Model: CPD-15SF2, CPD-17SF2

No. 145

Subject: No picture with Wide Vert. Sync. Pulse

Date: January 13, 1997

C948 & IC901 LOCATION

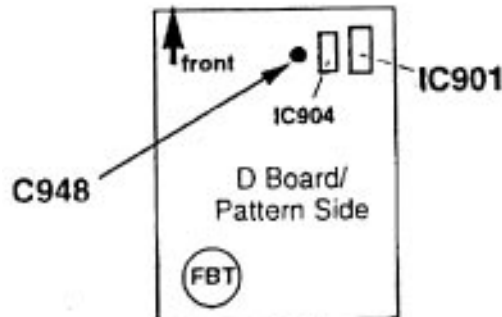
If set has no picture when Vert. Sync Input has Wide ($\geq 400 \mu\text{s}$) Vert. Sync. Pulse. Unit may not accept Vert. Sync. and go in Power Save mode.

1. Replace IC901. Refer to illustration shown below.
2. Replace C948 with 0.22 μF part. Refer to illustration shown below.
